RE: United Power Stonehouse Substation Conditional Use Permit – RCU2025-00008 Submittal 3

Ulteig on behalf of United Power, Inc. respectfully delivers this third submittal for the Stonehouse Substation Conditional Use Permit application RCU2025-00008.

Adams County Comments and United Power/Ulteig Responses

Figure 3 – Proposed Conditions

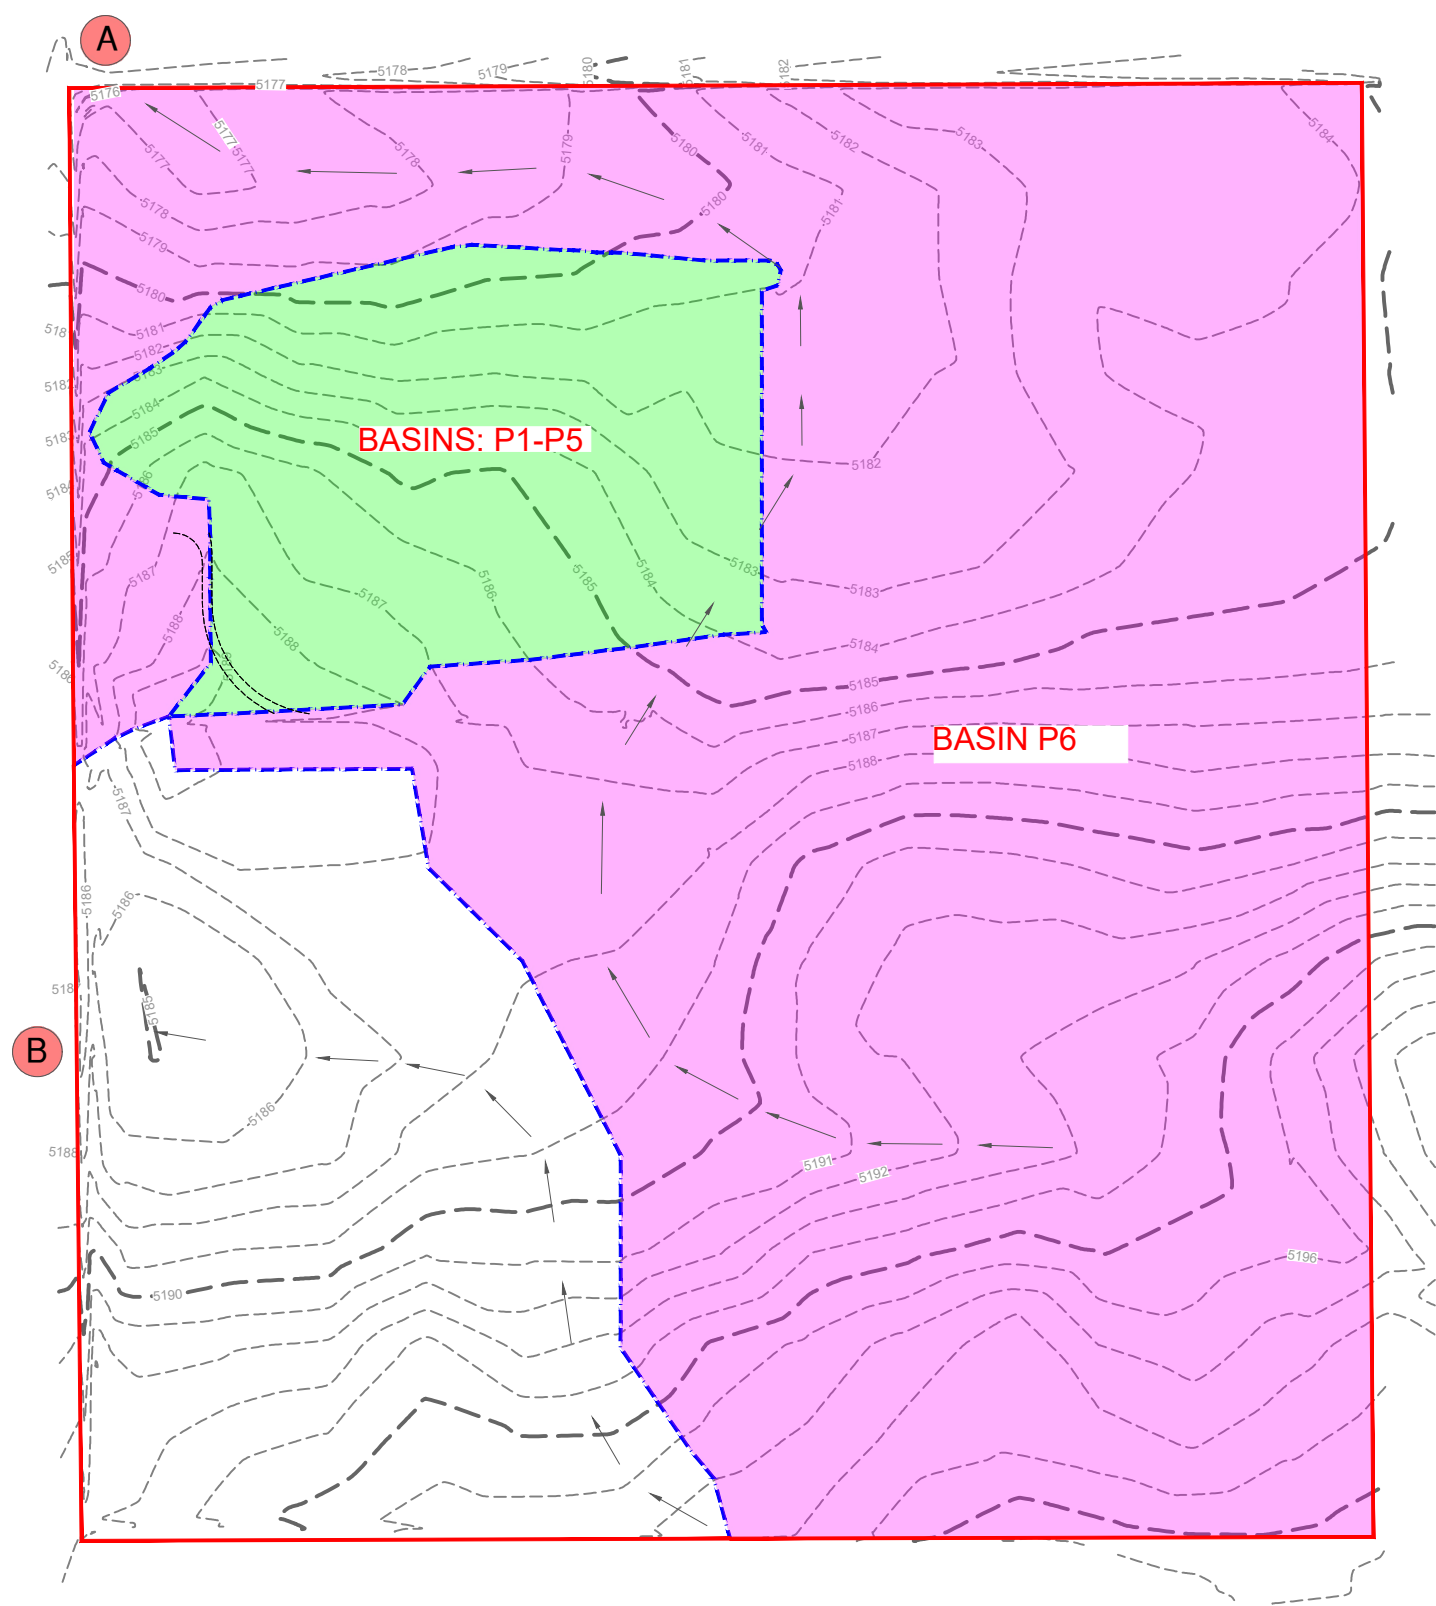
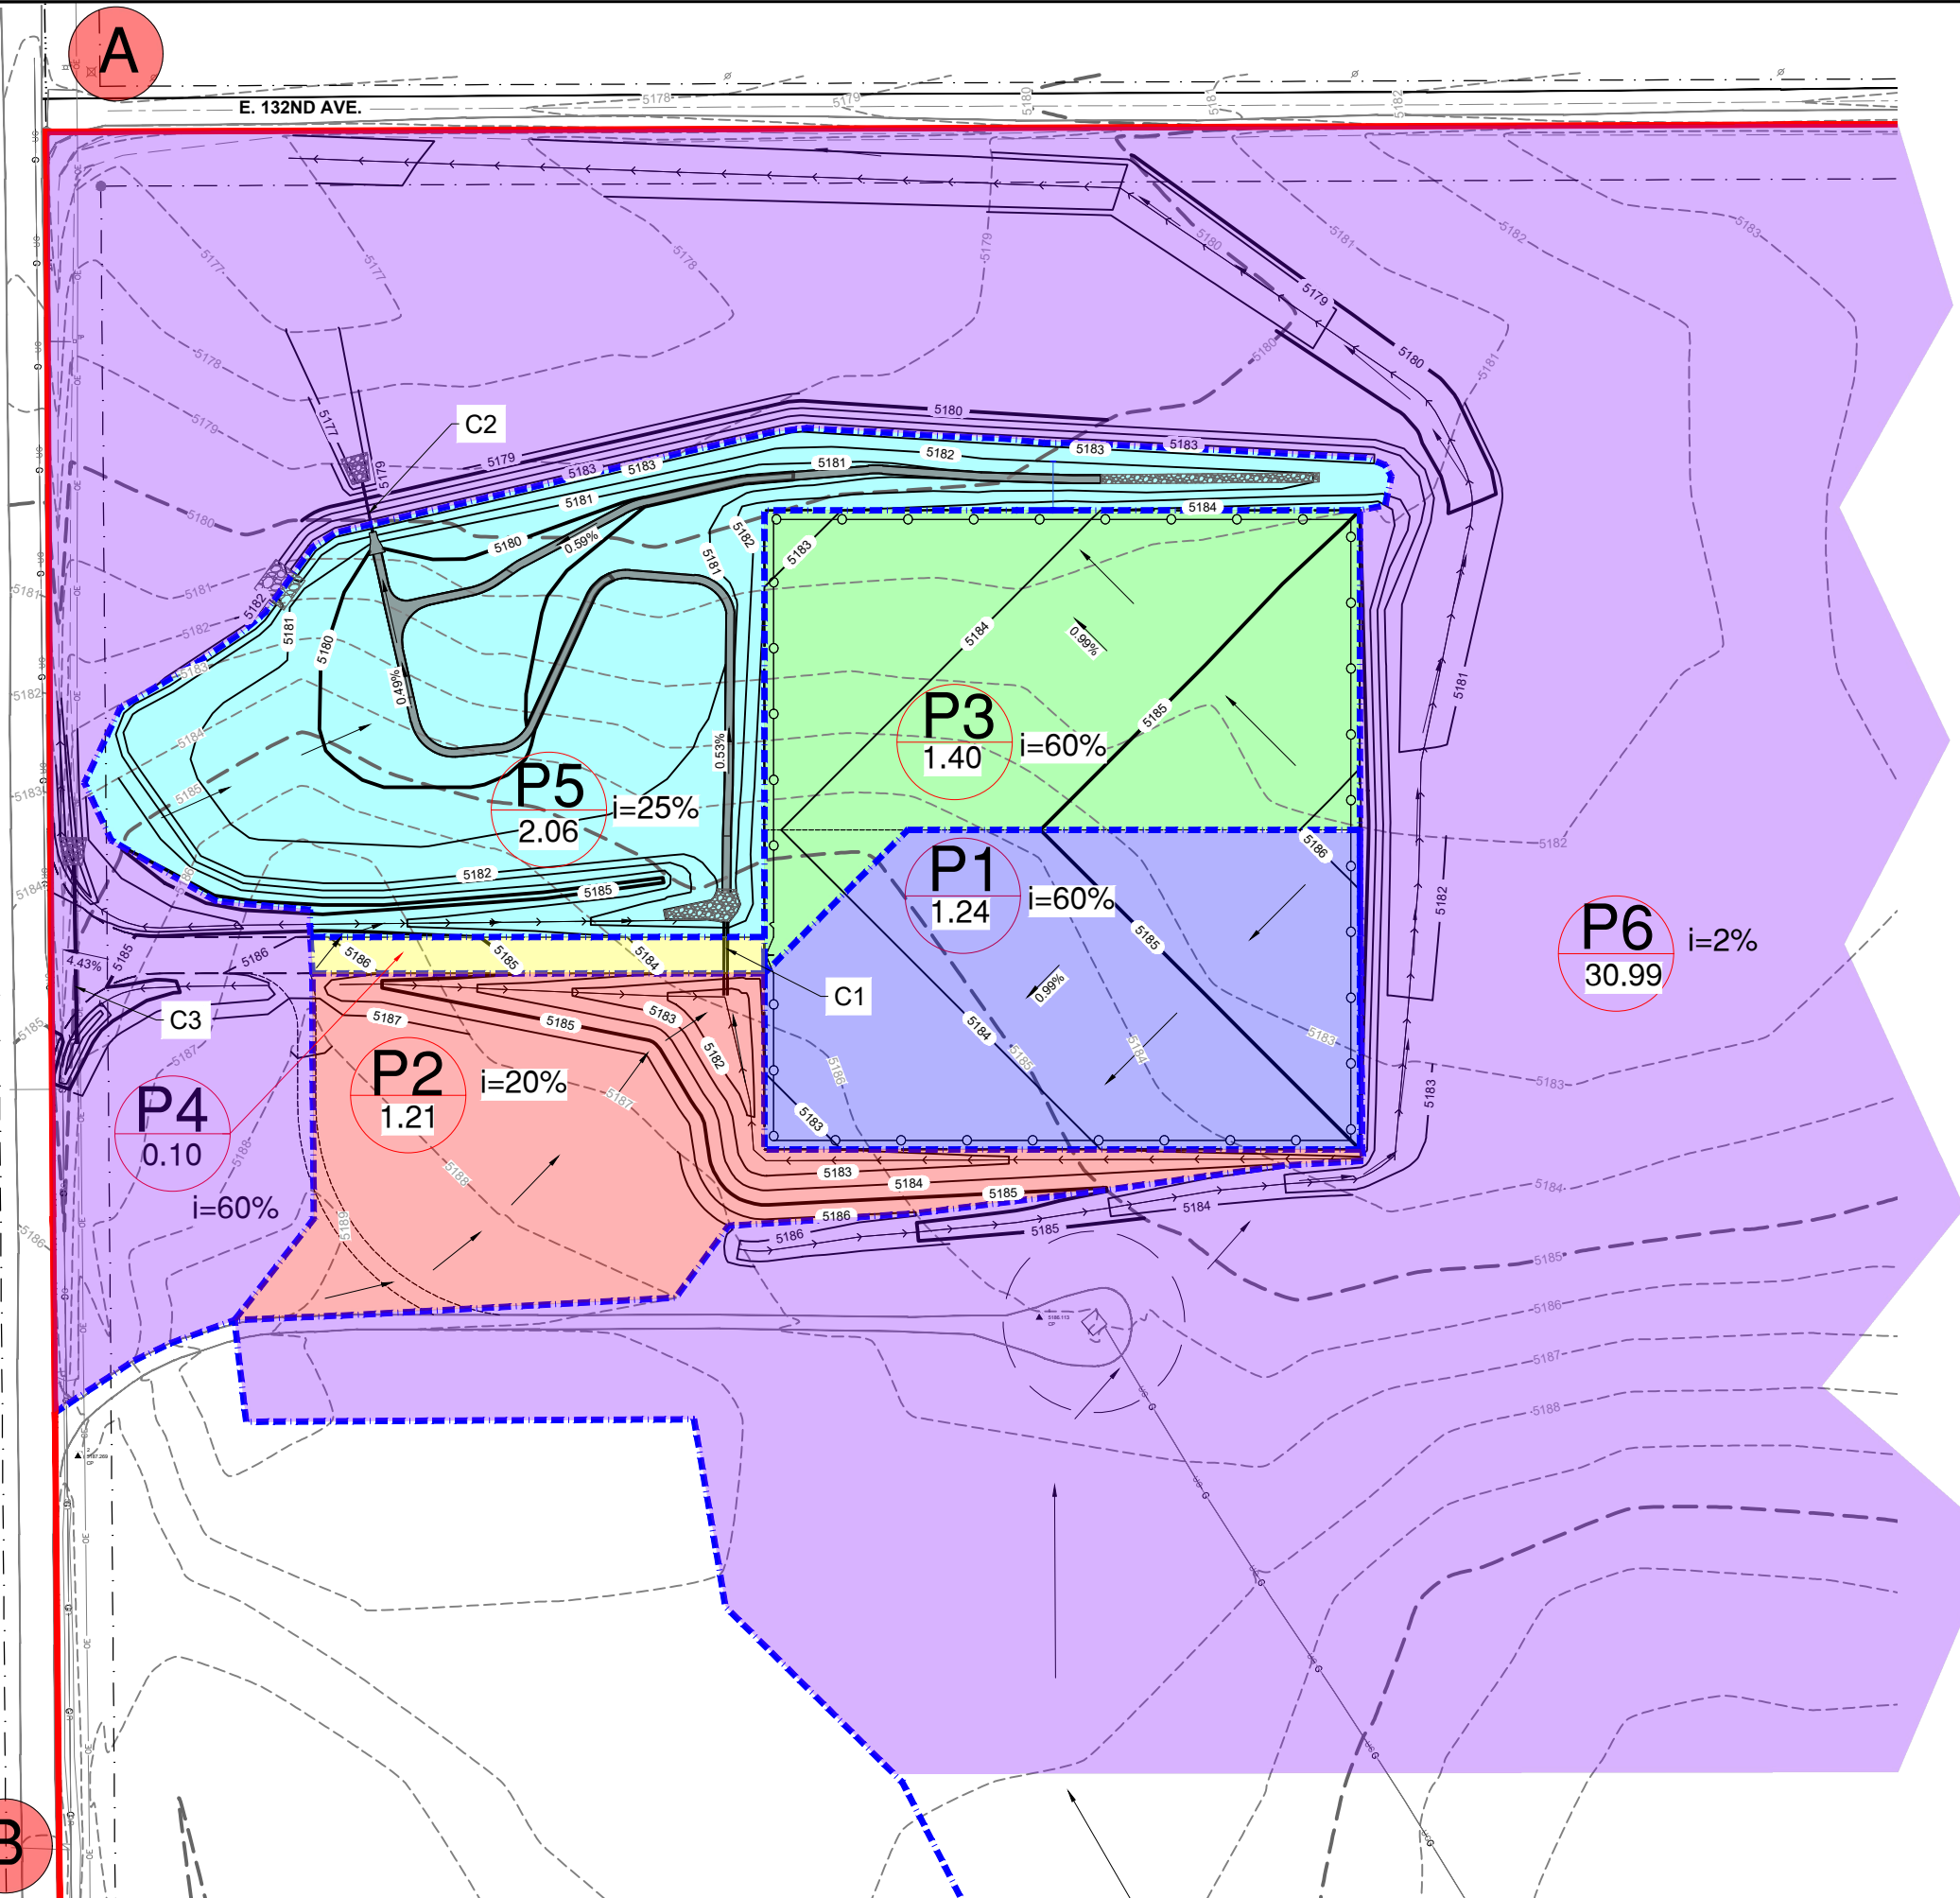
ENG4: With the EGR, provide a Grading and Erosion Control Plan:

- a. Cross sections for cut and fill areas for new ponds and staging areas.
- b. Designs and details of any proposed retaining walls that exceed three feet in height, if proposed.
- c. Provide more detail on the construction plans for the temporary stockpiling of topsoil. Provide silt fence/waddles at the base of all the soil stockpiles and along the bottom of the fill slopes.

d. Provide a detail for the concrete washout on the project site.

Response: Noted; however, a revised Preliminary Drainage Report and Plan have been included with this resubmittal.
